RESOLUTION CLOSING HEARING ON REQUEST BY QUEST DEVELOPMENT
AND CONSTRUCTION AND LAMONT COMPANIES TO REZONE PROPERTY AT
205 SW 11TH STREET FROM C-3B CENTRAL BUSINESS MIXED USE DISTRICT
TO PUD PLANNED UNIT DEVELOPMENT DISTRICT AND TO AMEND THE
RIVERPOINT WEST PUD CONCEPTUAL PLAN, AND CONDITIONALLY
APPROVING THE PUD CONCEPTUAL PLAN AMENDMENT

Communication from the City Plan and Zoning Commission advising that at their meeting held August 15, 2013, the following action was taken regarding a request from Quest Development and Construction and Lamont Companies (developer), represented by Kevin Weisbeck (officer), to rezone property at 205 Southwest 11th Street.

1. **Purpose of Request:** The applicant proposes to add 4.09 acres to the Riverpoint West PUD and amend the existing PUD Conceptual Plan to allow development of a 102-room hotel in place of the approved 93-room hotel at the southwest corner of the site. The proposed PUD Conceptual Plan designates 6.84 acres for future

Additional Area to be rezoned to PUD Existing PUD Area to be amended

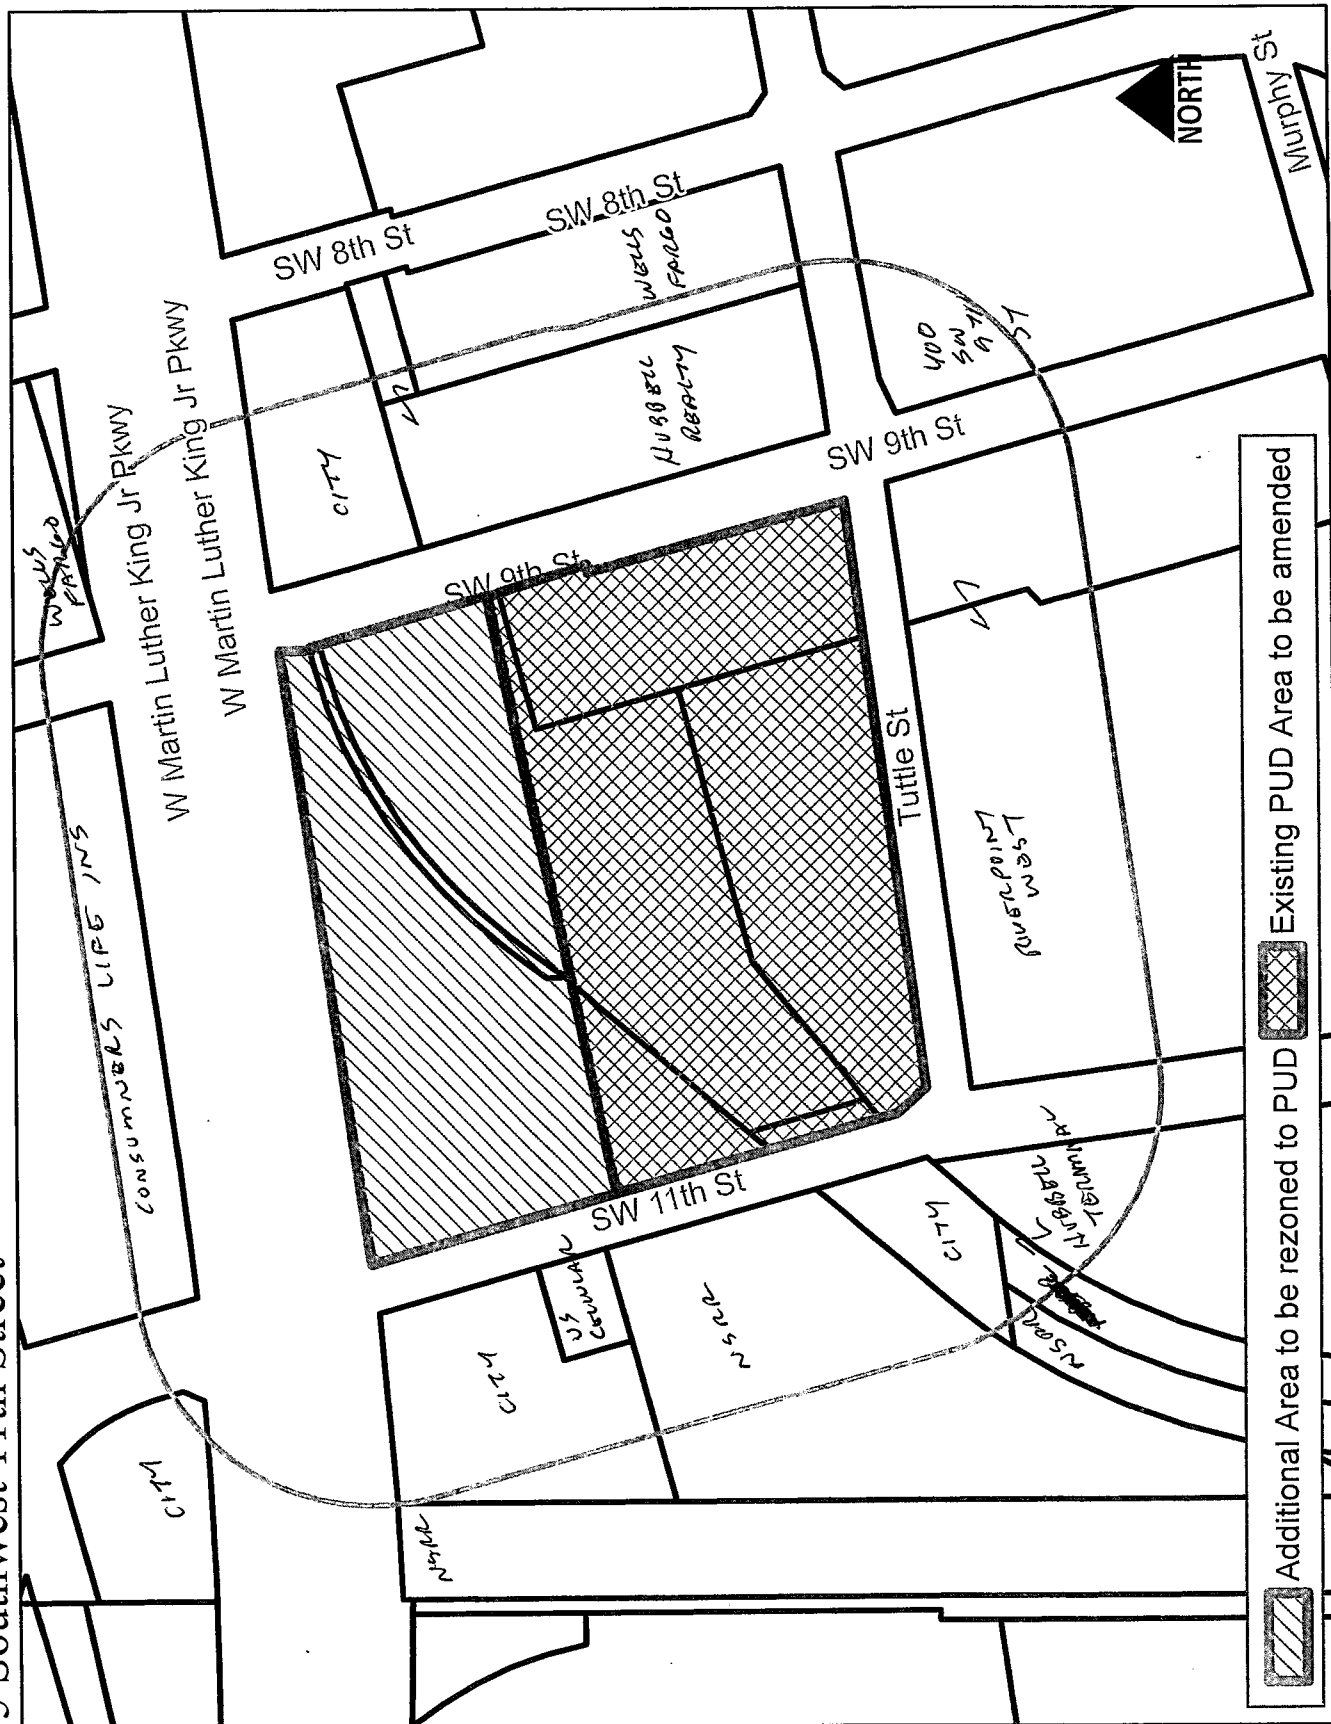
The submitted PUD Conceptual Plan allows development of a 4-story hotel with 102 guest rooms on a 1.9-acre area at the southwest corner of the site. The balance of the PUD would be limited to uses as permitted in the "C-3B" District. Staff recommends that a note be added to the PUD Conceptual Plan to state that future development of the balance of the PUD shall be subject to review and approval of an amendment(s) to the PUD Conceptual Plan by the Plan & Zoning Commission.

The site is within an area known as the Gray's Lake Office Park/Gray's Landing, which is planned to be a vibrant mixed-use area with a pedestrian-friendly urban setting. Both Southwest 11th Street and Tuttle Street are considered primary pedestrian corridors for this area. To create a welcoming pedestrian environment, it is vital that buildings frame these streets with minimal setbacks and that pedestrian amenities are provided. Ideally, the building at the corner of Southwest 11th Street and Tuttle Street should be oriented toward both streets to activate the corner. Staff recommends that the proposed entrance on the south façade facing Tuttle Street be revised to be similar in size and design of the entrance proposed for the west façade facing Southwest 11th Street. Staff also recommends that the outdoor plaza at the southwest corner of the site be extended to the entrance on the façade facing Tuttle Street.

2. **Urban Design:** The proposed elevations indicate that the hotel building would be 4 stories in height and contain 102 guest rooms. The building would be constructed primarily with stone and thin brick materials, with Hardi-panel and EIFS accents. The PUD Conceptual Plan proposes details to demonstrate how the thin brick will be installed, specifically around window heads, jambs, and sills. Staff notes that the details indicate a 'flat' elevation at windows, which is contrary to the desired appearance. The details should also demonstrate how the thin brick will be installed adjacent to the various other proposed materials, such as EIFS, Hardi-panel, the ground, and landscaping. Therefore, staff recommends approval of the PUD Conceptual Plan be subject to modification of these details to the satisfaction of the Planning Administrator.

3. **Refuse Collection Container Enclosure:** The PUD Conceptual Plan includes a note to state the enclosure will be comprised of materials compatible with the primary building architecture and shall be constructed of durable materials such as stone or masonry, with an opaque metal gate. It also demonstrates a refuse collection container enclosure at the northeast corner of the building. Given the visibility from Southwest 11th Street, staff recommends the enclosure be move further east within the parking lot.

Staff has concerns within the size and design of the proposed sign. Given the desired pedestrian-scale of the area, staff recommends any signage along West Martin Luther King, Jr. Parkway be in accordance with the following:

- (1) A note shall be added to the PUD Conceptual Plan to state that future development of the balance of the PUD shall be subject to review and approval of an amendment(s) to the PUD Conceptual Plan by the City Council after report and recommendation by the Plan & Zoning Commission.

- (2) A note shall be added to the PUD Conceptual Plan to state that future development of the land to the east of the proposed hotel shall include a building that substantially frames Tuttle Street and is as far east as possible. Prior to City Council's approval of the PUD Conceptual Plan amendment for the hotel, the developer shall provide a conceptual sketch that demonstrates how the sewer, stormwater and parking would be generally configured to accommodate the layout for the second building in the described location.

- (3) The entrance on the south façade facing Tuttle Street shall be similar in size and design to the proposed entrance on the west façade facing Southwest 11th Street.

- (4) The outdoor plaza at the southwest corner of the site shall be extended east to the entrance on the building's south façade facing Tuttle Street.

- (5) The architectural details regarding the installation of thin brick at window heads, jambs, sills, EIFS, Hardi-board, the ground, and landscaping shall be modified and expanded to the satisfaction of the Planning Administrator.

- (6) An overall signage plan shall be submitted for review by staff, recommendation by the Plan and Zoning Commission, and approval by the City Council. No non-building-mounted signage will be permitted or constructed until the overall sign plan for Grays Lake Office Park is approved.

- (7) The refuse collection container enclosure shall be shifted east and/or additional Landscape screening shall be added.
